CITY CENTRE WEST TO EAST CYCLE LINK

Road Safety Audit Stage 1 Designers Response

City of Edinburgh Council

636809_0_RP_Z_00_0030

Drawing(s) TDD-636809-1.3-DR-CH-00-0003

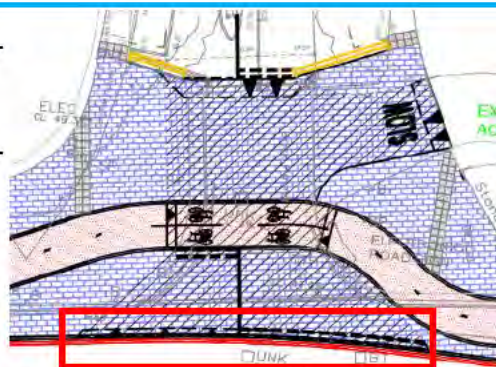
It is recommended that road markings are provided on approach to the loading bay to guide motorists around it when empty.

Recommendation rejected.

West Coates

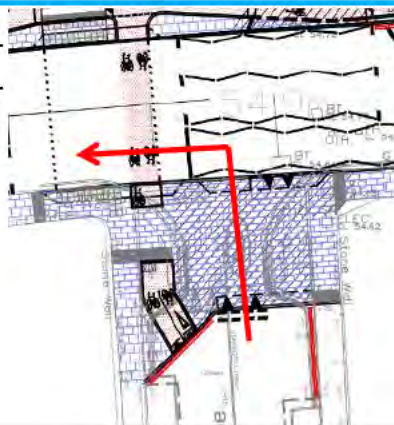
It is recommended that the short length of Bus Lane to the west of Balbirnie Place is removed and the road markings are amended accordingly to provide an appropriate merge taper length.

The merge length provided westbound is 1:10; there is no guidance for urban merge lengths following the termination of bus lanes however the principles for merging in advance of other obstacles set out in TSM Chapter 3 have been considered as part of the design process. For bus lane commencement the guidance suggests "normally a taper no sharper of 1:10. There may be situations where it is not practicable to provide a taper of 1:10 and a sharper taper is necessary. In such circumstances, care should be taken to ensure that traffic is directed away from the start of the bus lane in a safe manner." Noting the proposed 20mph speed limit and urban environment, and the low risk associated with the merge being between general traffic (offside lane) and buses (nearside lane) as opposed to two general traffic streams, the facility is proposed to be retained to prioritise mitigating the safety risk with the loading bay.

Problem 4.1.5**Location(s)** Stanhope Street**Drawing(s)** TDD-636809-1.5-DR-CH-00-0005**Summary:** Proximity of crossing to junction could lead to vehicular-cyclist and / or head-on collisions**Description:**

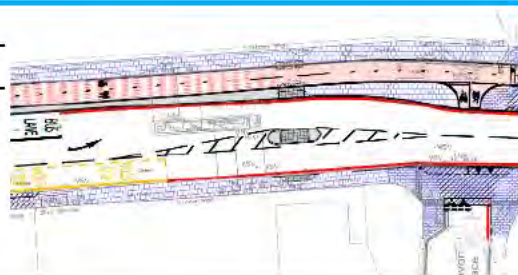
It is recommended that swept paths are undertaken for all movements at the junction, and the layout is amended to remove the risk of collisions. For example, Stanhope Street could be made one-way, or be closed, or the crossing could be relocated.

Recommendation accepted.

Subsequent to the Stage 1 RSA Stanhope Street has been amended to be one way southbound.

Problem 4.1.7**Location(s)** Morrison Street**Drawing(s)** TDD-636809-1.7-DR-CH-00-0007**Summary:** Buses travelling across the cycle lane could lead to bus-cyclist collisions**Description:**

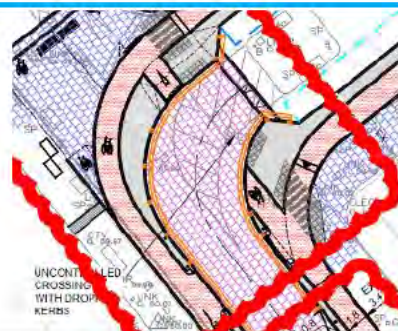
It is recommended that the swept paths of vehicles including buses are undertaken along this road, and lane widths adjusted as necessary.

Recommendation accepted.

| <i>Drawing(s)</i> | TDD-636809-2.5-DR-CH-00-0005 |

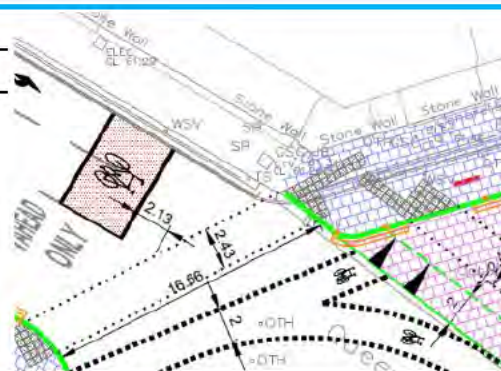
It is recommended that swept paths are undertaken to ensure that vehicles using the route can undertake the movement within their lanes, and without overrunning the adjacent footway / cycleway, and the layout amended if necessary.

Recommendation accepted in part.

| Drawing(s) | TDD-636809-2-DR-CH-SK-0030 |

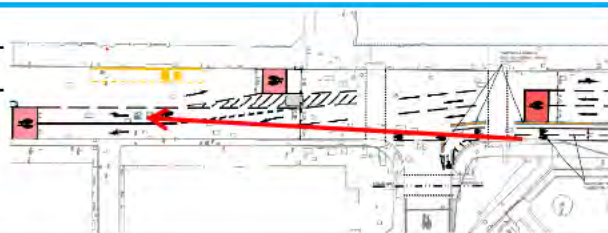
The proposed amendments to the nearside kerb between Drumsheugh Place and Randolph Place do not produce a smooth alignment. As such it is likely that the new corner kerb will be overrun by vehicles turning left into Randolph Place. This could lead to collisions between vehicles and pedestrians waiting to cross. Regular overrunning of kerbs could also lead to break up of the footways and kerbs. This could lead to loose material in the carriageway with the potential for loss of control collisions.

It is recommended that the kerb ties in smoothly, and its alignment accommodates the swept path of vehicles expected at the junction.

| Drawing(s) | TDD-636809-4-DR-CH-SK-0007 |

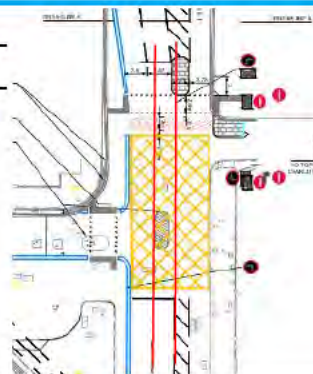
| <p>The northbound lanes are not aligned across the junction (as per the red lines in the image above). Motorists in the offside lane may encroach into the nearside lane with the potential for side-swipe collisions. Also, vehicles in the nearside lane will be guided towards the kerb opposite. This could lead to motorists undertaking a sudden change in direction, with the potential for loss of control and / or side-swipe collisions to occur. Similarly, vehicles in the offside southbound lane may encroach into the nearside lane (as per the green lines in the image above) with the potential for side-swipe collisions.</p> |

| <p>Recommendation accepted.</p> |

| <p>Designer will consider the alignment of northbound and southbound lanes to better align the north and south links at the Rose Street junction.</p> |

Drawing(s) TDD-636809-4-DR-CH-SK-0007

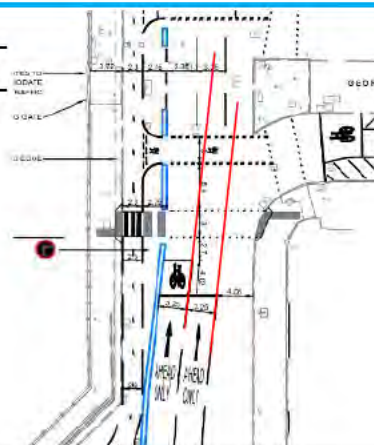
The northbound lanes are not aligned across the junction (as per the red lines in the image above). Motorists in the nearside lane may encroach into the offside lane with the potential for side-swipe collisions. Also, vehicles in the offside lane will be guided towards the kerb opposite. This could lead to motorists undertaking a sudden change in direction, with the potential for loss of control and / or side-swipe collisions to occur.

It is recommended that the road markings and kerb lines are adjusted as necessary to improve the lane alignment through the junction.

Recommendation accepted.

Problem: 4.3.3**Location(s):** Roseburn Gardens**Drawing(s):** TDD-636809-1-DR-CH-SK-0036

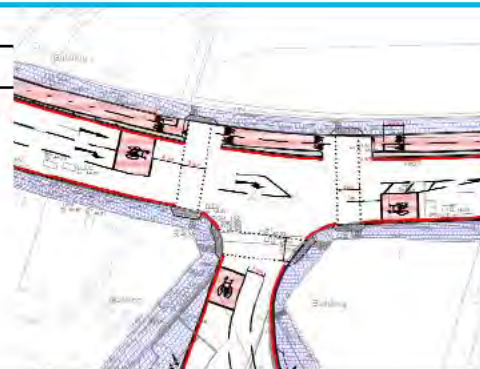
- the splitter island is extended to the stop line and

physical measures are provided adjacent to the crossing, in order to prevent the right turn movement, and keep left turning vehicles away from waiting pedestrians.

- A bell bollard is proposed to the west of the pedestrian crossing to remove the risk of drivers taking a shallow alignment across the pedestrian waiting area. Traffic signal poles are also present immediately to the west of the tactile paving.

Problem: 4.3.4**Location(s):** Roseburn Terrace / Russell Road junction**Drawing(s):** TDD-636809-1.3-DR-CH-00-0003**Summary:** Concurrent green signals could lead to vehicular-cyclist collisions**Description:**

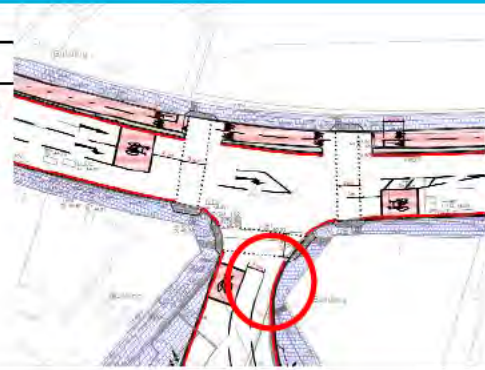
It is recommended that the cycleway does not have a green signal at the same time as Russell Road.

Recommendation rejected.

2) Russell Road is not being promoted as an access point to the two-way cycle track, primarily due to physical constraints at the junction. Access can be gained for confident cyclists on carriageway however the sign routes are proposed as identified in the response to item 4.3.8.

Problem: 4.3.5**Location(s):** Roseburn Terrace / Russell Road junction**Drawing(s):** TDD-636809-1.3-DR-CH-00-0003**Summary:** Narrow lanes could lead to side-swipe, shunt and / or head-on collisions**Description:**

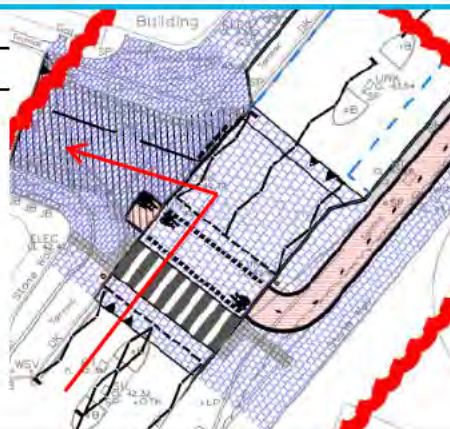
Two lanes are marked upon entry into Russell Road. However, the lanes are approximately 2.0 m to 2.5 m wide. The traffic signal staging is such that vehicles can turn right into Russell Road at the same time as vehicles turning left into Russell Road. A motorist turning right could see the downstream area marked as two lanes and turn at the same time as a vehicle turning left. The narrow width of the lanes around the corner however, could result in side-swipe or shunt collisions between these two vehicles, and / or head-on collisions with a vehicle waiting at the Russell Road stop line.

It is recommended that the entry to Russell Road is marked as a single lane, widening to two lanes where there is sufficient width for two vehicles to travel side by side.

Problem: 4.3.6**Location(s):** Roseburn Place / Roseburn Street junction**Drawing(s):** TDD-636809-1.3-DR-CH-00-0003**Summary:** Proximity of crossing to side road could lead to vehicular-pedestrian / cyclist collisions, and / or head-on collisions**Description:**

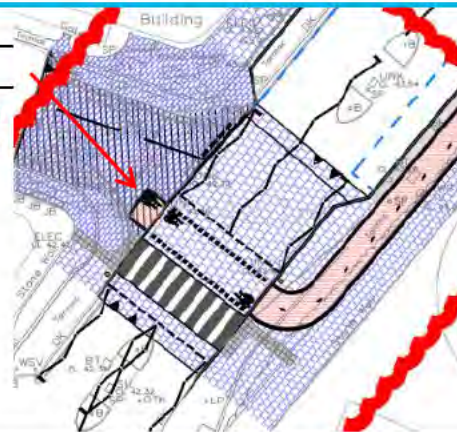
It is recommended that the crossing is relocated such that all turning movements can be performed without risk of overrunning pedestrian / cycle waiting areas or travelling in an opposing traffic lane towards oncoming traffic.

The crossing is to be retained in its current position to maintain the pedestrian and cycle desire line, though the risk is acknowledged with the current layout. Therefore an alternative solution is proposed to provide a bell bollard to protect the cycle and pedestrian crossing from overrunning whilst allowing the traffic turning movements.

West Coates / Russell Road junction

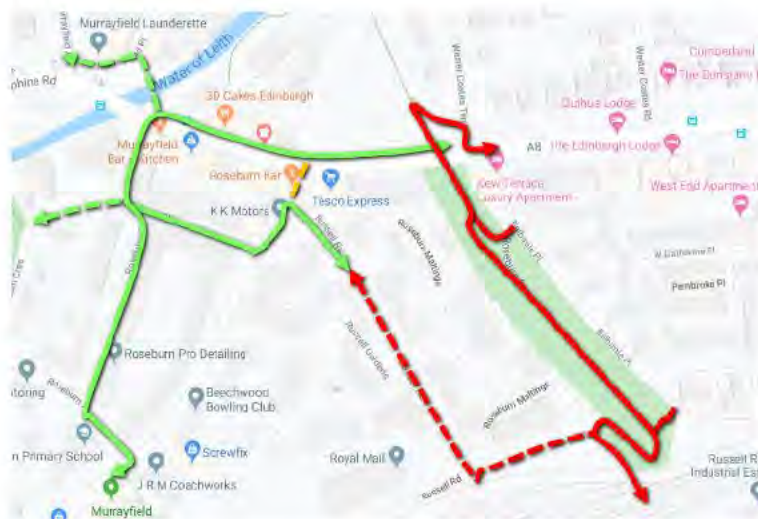
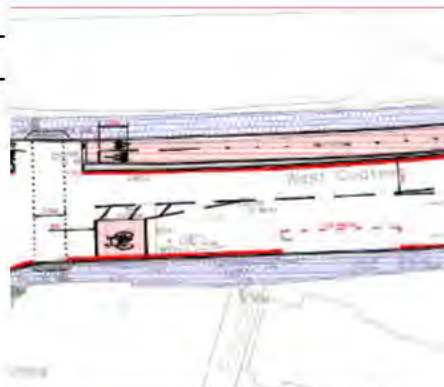
Cyclists on the West Coates cycleway wishing to continue south to Russell Road may believe they can turn at the road junction when they have a green signal. This would create the potential for shunt, side-impact and / or side-swipe type collisions with vehicles travelling through the junction at the same time.

It is recommended that provision is made for cyclists to safely cross West Coates in order to continue to Russell Road / Roseburn Street.

Recommendation accepted: Crossing facilities are provided along Roseburn Terrace and West Coates however these are provided based on desire lines and constraints. There is a wider routing strategy for access to the CCWEL corridor that will be signed accordingly, which offers a more appropriate off-carriageway facility than the exiting on-carriageway via Russell Road.

| <i>Drawing(s)</i> | TDD-636809-1.3-DR-CH-00-0003 |

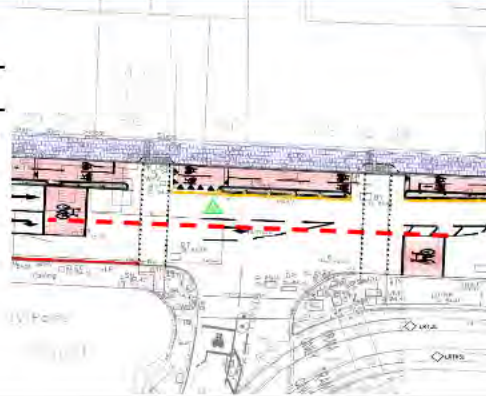
It is recommended that measures are incorporated to ensure that the traffic signals can be seen should the loading bay be occupied, such as increased height signals, and offside primary signals. If this is not possible then it is recommended that the loading bay is relocated outside of the visibility splay for the signals.

Recommendation accepted.

An offside primary signal head could be confusing in this location to cyclists on the two-way cycle track. A double height pole is proposed to be added to Pole 7 with an additional high level signal head, but will require a side mounted cowl to prevent light spillage towards properties on the south side of Roseburn Terrace.

| <i>Drawing(s)</i> | TDD-636809-1.6-DR-CH-00-0006 |

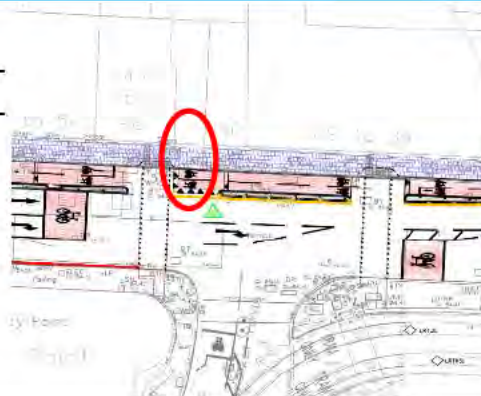
The offside of the westbound lane approaching the junction is aligned with the centre of the eastbound right turn lane and right turn pocket opposite (as indicated by the red dashed line in the above image). This could lead to head-on collisions and / or sudden braking / change of direction leading to shunt or loss of control collisions.

It is recommended that the westbound approach lane is aligned with the westbound departure lane from the junction.

Recommendation accepted.

Problem 4.3.13**Location(s)** Clifton Terrace**Drawing(s)** TDD-636809-1.6-DR-CH-00-0006

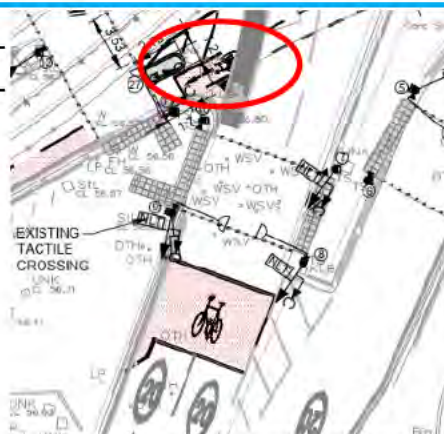
road markings are provided to highlight the narrowing of the lane on approach to the bus stops

Recommendation accepted.

The layout for this crossing is to be updated to provide fully segregated cycle access to/from Clifton Terrace and the two-way cycle track. This includes removal of the westbound ahead facility audited to be replaced with an ASL with lead-in cycle lane at the crossing. Diag 1057 cycle symbols are proposed on approach to and past the bus stops in either direction to highlight the presence of cyclists.

| <i>Drawing(s)</i> | TDD-636809-2.6-DR-CH-00-0006 |

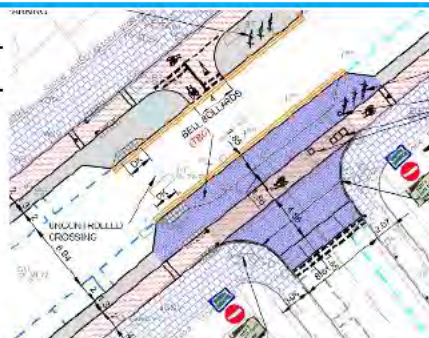
It is recommended that appropriate road signs and road markings are provided such that it is clear as to the direction of travel on each section.

Recommendation accepted.

Problem: 4.4.21**Location(s):** Stafford Street**Drawing(s):** TDD-636809-2.7-DR-CH-00-0007**Summary:** Lack of tactile guidance could lead to collisions between visually impaired pedestrians and cyclists**Description:**

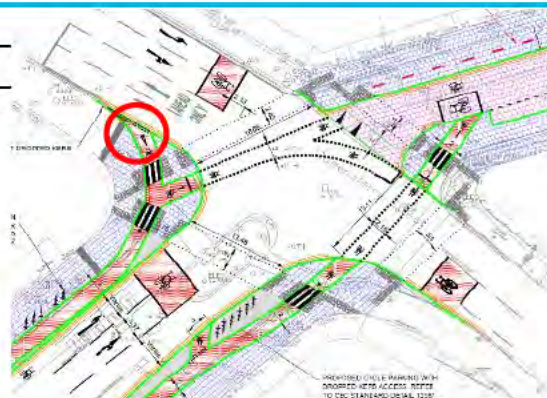
There is nothing to inform visually impaired pedestrians that they are entering a route where cyclists may be present. This could result in the visually impaired walking into the path of cyclists, with the potential for collisions between the two, noting that forward visibility is also limited in some areas.

It is recommended that appropriate tactile guidance is provided for the visually impaired entering the route so that they are aware that cyclists may be present.

The layout has been updated to provide blister tactile paving to warn pedestrians that they are entering a continuous footway, as per updated Edinburgh Street Design Guidance.

Problem: 4.4.25**Location(s):** Rutland Street / Lothian Road**Drawing(s):** TDD-636809-2.12-DR-CH-00-0012**Summary:** Lack of continuation of cycle facilities could lead to vehicular-cyclist collisions**Description:**

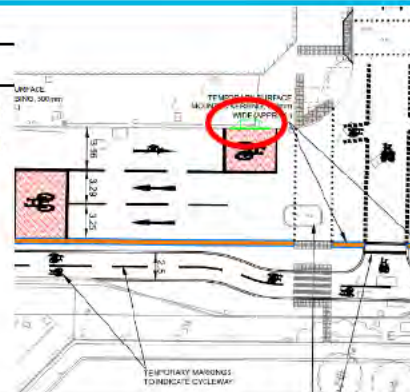
It is recommended that measures are provided to assist cyclists in joining the southbound carriageway safely, for example, through the provision of a central refuge.

Recommendation rejected.

Problem: 4.4.27**Location(s):** Charlotte Square**Drawing(s):** TDD-636809-4-DR-CH-SK-0007**Summary:** Lack of information for visually impaired pedestrians could lead to trips and falls, and / or cyclist-pedestrian collisions**Description:**

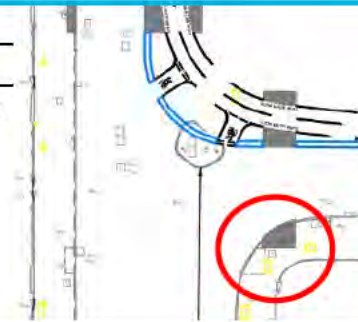
Tactile paving is provided at the crossings of Charlotte Square to the west of South Charlotte Street and North Charlotte Street, and then again at the crossing of the cycleway. However, it is considered that a visually impaired pedestrian would find it very difficult to negotiate the route through to the footway. If they were to continue straight after departing the road crossing they would encounter a full height kerb opposite, which could cause them to trip and fall, leading to personal injury. They would be likely to be unaware that they were crossing the cycleway, with the potential for being struck by a cyclist. They would then encounter another trip hazard at the steps, with the potential for injury.

It is recommended that a tactile surface is provided to lead visually impaired pedestrians between the crossings and to the base of the steps, with appropriate tactile surfacing at the top and bottom of the steps at both the northern and southern sides of the square.

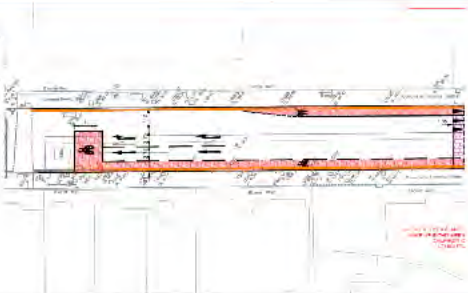
Triangle road markings are proposed on the two eastbound approaches to the raised table. However, they extend across the offside half of the ramps. This, coupled with the fact that there are no central lane markings on either approach, could lead motorists into thinking that they are on one-way routes. Approaching motorists may enter the ramp centrally within the carriageway, with the potential for head-on collisions with westbound vehicles.

It is recommended that the triangles are provided to align with the eastbound lanes only on both approaches.

The number of triangles will need to be reduced to two to achieve this mitigation, and aligned so the easternmost triangle is visible offline from the parking bays.
